Project	IEEE 802.16 Broadband Wireless Access Working Group <http://ieee802.org/16>	
Title	Correction to TFTP-RSP message	
Date Submitted	2004-04-28	
Source(s)	Itzik Kitroser Yossi Segal Yigal Leiba Zion Hadad Runcom Technologies Ltd. 2 Hachoma St. 75655 Rishon Lezion, Israel	Voice: +972-3-9528440 Fax: +972-3-9528805 mailto:itzikk@runcom.co.il mailto:yossis@runcom.co.il mailto:yigall@runcom.co.il mailto:zionh@runcom.co.il
Re:	802.16-REVd Sponsor ballot recirc	
Abstract	This contribution provides correction to an undefined state or authentication failure in the TFTP-CPLT message	
Purpose	Adopt suggested changes into P802.16-REVd/D4 draft	
Notice	This document has been prepared to assist IEEE 802.16. It is offered as a basis for discussion and is not binding on the contributing individual(s) or organization(s). The material in this document is subject to change in form and content after further study. The contributor(s) reserve(s) the right to add, amend or withdraw material contained herein.

Correction to TFTP-RSP message

6.3.2.3.29 Config File TFTP Complete Response (TFTP-RSP) message

Figure 69—Wait for TFTP-RSP—SS

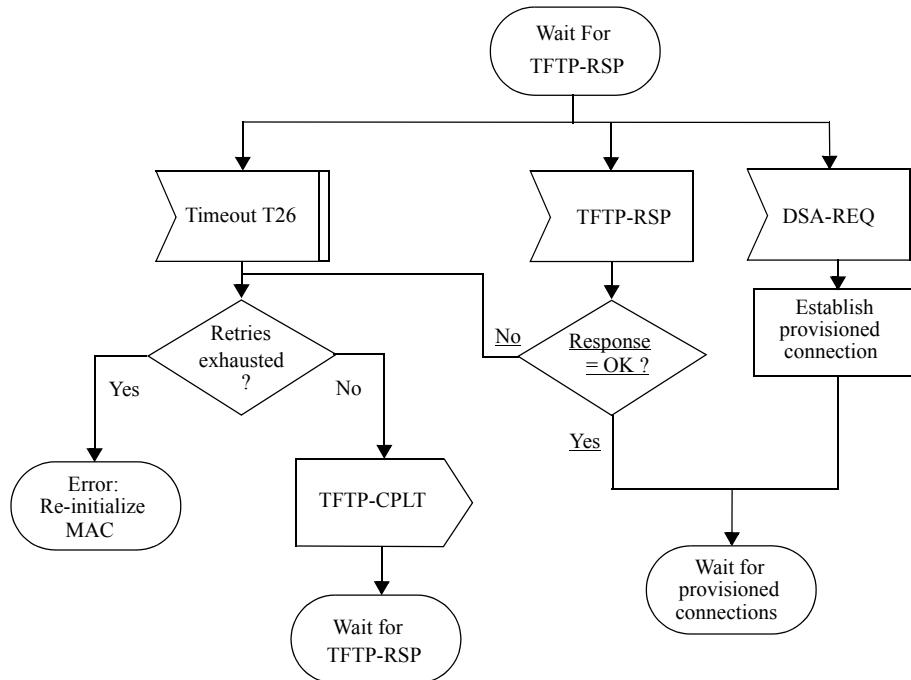
In the TFTP-CPLT message, the SS must send HMAC tuple for authentication, while in the TFTP-RSP there is no response field. This means that the case of authentication failure the state is undefined. If the SS does not receive an answer, then it doesn't know if it because of authentication failure or the messages was lost, and will have to time-out and retransmit.

[Page 170, line 29, section 6.3.9.12 change figure 69 as indicated]

When the configuration file download has completed successfully, the SS shall notify the BS by transmitting a TFTP-CPLT message on the SS's primary management connection. Transmissions shall continue periodically until a TFTP-RSP message is received with OK response from the BS (see Figure 69 and Figure 70) or the SS terminates retransmission due to retry exhaustion.
